UNITED STATES PATENT AND TRADEMARK OFFICE

Office Action Summary

10/530,077

DETAILED ACTION

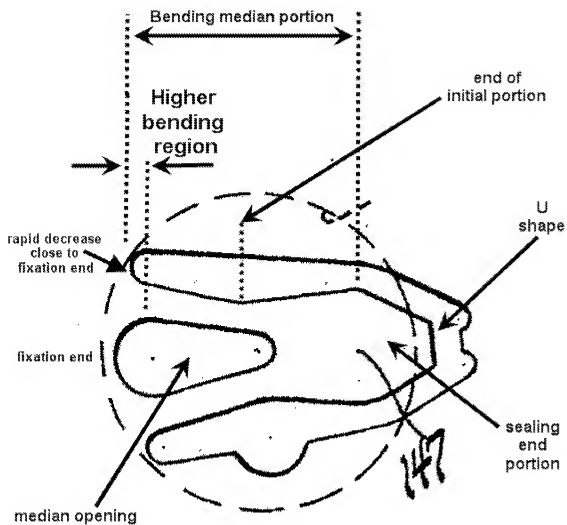
4. In Re claim 1, with reference to Figure 5 depicted above, Black et al discloses a suction valve (147) with a compression cylinder (165), which has one end closed by a valve plate (77), said valve comprising a flexible vane shaped to present:

- a fixation end portion (as depicted)

- a bending median portion (as depicted) provided with a median opening (149) and a sealing end portion (as depicted) operatively associated with a suction orifice (145) provided in the valve plate (77)
- wherein the distance between an external edge of the flexible vane and its adjacent internal edge portion of the median opening diminishes progressively along a higher bending region from a maximum value close to end fixation portion to a minimum value at the close to the boundary of the higher bending region (as depicted above)

- the bending median portion and sealing end portion presents a U shape (as depicted)
- legs of the U shape are symmetrical about a longitudinal axis of the vane, they are equal length, and are united by the fixation end portion (as depicted, the fixation end is part of the fixation end portion)

5. In Re claim 2, Black et al discloses that the width of the median opening increases progressively from a region adjacent to the fixation end portion to the opposite boundary of the higher bending region (as depicted), whereas the total width of the flexible vane diminishes from the fixation end portion to the end of the initial portion as depicted and then it begins to progressively increase towards the sealing end portion. With regards to "from before the opposite boundary", when the point of reference is the tip of the U shape, the end of the initial portion is "before" the "opposite boundary of the higher bending portion".

6. In Re claim 5, Black et al discloses the distance between the external and internal edges diminishes more rapidly close to the fixation end portion than along the rest of the higher bending region.

Table A-9

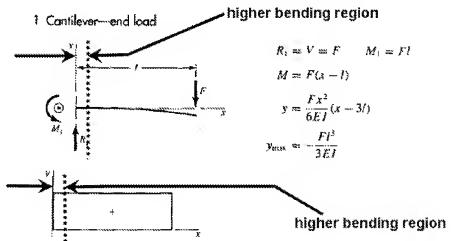
- with reference to Shigley et al, Table A-9 above depicts a cantilever (flexible vane) under end load (force due to suction in an open position of the vane). As evidenced from the shear force diagram, the shear force (V) resulting from the opening of the valve is uniformly distributed along the higher bending region NO MATTER HOW SMALL the higher bending region is. Further, as evidenced from the deflection (y) diagram, the deflection of the vane (y) is NOT a linear function of (x) implying that the vane has a curved shape in the higher bending region NO MATTER HOW SMALL the

higher bending region is. Therefore the vane IS bent in the higher bending region (due to its curved shape)

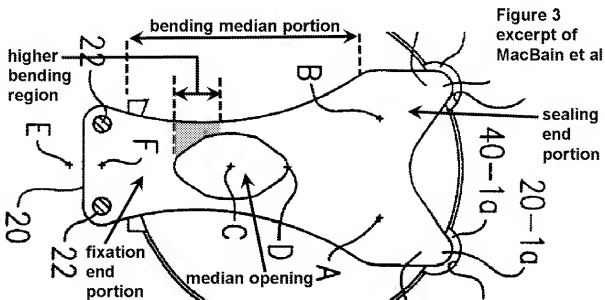
7. In Re claim 9, Shigley et al discloses that the shear force is transmitted to the entire vane since it is formed in one piece, therefore the opening forces are not concentrated in any region.

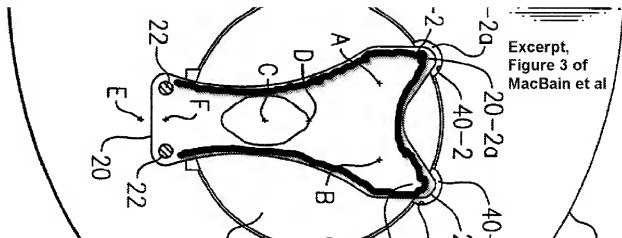
10. In Re Claim 1, with reference to Figure 3 annotated above, MacBain et al discloses a suction valve for a small hermetic compressor (Abstract states "compressor suction valve") of the type presenting a compression cylinder (D) which has an end closed by valve plate (30), said valve comprising:

- a fixation end portion (annotated) to be affixed to the valve plate;
- a bending median portion (annotated) provided with a median opening (annotated) aligned with a discharge orifice (see Figure 1); and

- a sealing end portion (annotated) operatively associated with the suction orifice provided in the valve plate,
- wherein the distance between an external edge of the flexible vane and its adjacent internal edge portion of the median opening diminishes, along a higher bending region (as annotated by the shaded area, the width of which decreases along the higher bending region) of the flexible vane of the valve, from a maximum value, close to the end fixation portion, to a minimum value, close to the boundary of the higher bending region of the flexible vane,

- wherein the flexible vane is configured to distribute opening forces along the higher bending region (no areas of stress concentration) allowing the flexible vane to be bent along the higher bending region in an open position, and

- the bending median portion and sealing end portion "presents" a U shape as annotated below, with the legs being symmetrical about a longitudinal axis of the flexible vane, are of equal length and are united by the fixation end portion as depicted

(Note that the limitation "presenting" could also be broadly interpreted as enclosing a U shape, since the outline is not being claimed as U shaped. Further, the "united by" limitation could be interpreted as bringing the two legs together.)

11. In Re Claim 2, the width of the median opening increases as the total width of the vane decreases. The end of the initial portion is near the center of the median opening.
12. In Re Claim 3, as depicted, the median opening has a substantially semi elliptical contour as depicted.
13. In Re Claim 4, the median opening has an elongated oval (egg) shape.
14. In Re Claim 9, the stress is not concentrated in the region of the bending median portion that is adjacent to the fixation end portion.

FIG. 4

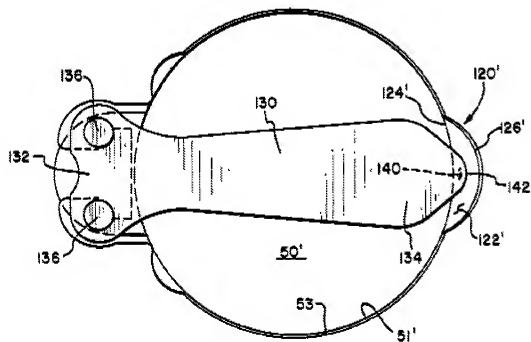
26. In Re claim 2, Black et al discloses that the width of the median opening increases progressively from a region adjacent to the fixation end portion to the opposite boundary of the higher bending region (as depicted), whereas the total width of the flexible vane diminishes from the fixation end portion to the end of the initial portion as depicted and then it begins to progressively increase towards the sealing end portion.

27. However, Black et al does not disclose "from before the opposite boundary", when the point of reference is the base at the fixed end.

28. Nevertheless, Kandpal discloses that the total width decreases at first but then progressively increases "from before the opposite boundary of the higher bending region".

29. It would have been obvious to a person having ordinary skill in the art at the time of the invention to modify the contour of the vane of Black et al so that the width progressively increases "from before the opposite boundary of the higher bending region" as taught by Kandpal as an alternative design choice for the contour of the vane.
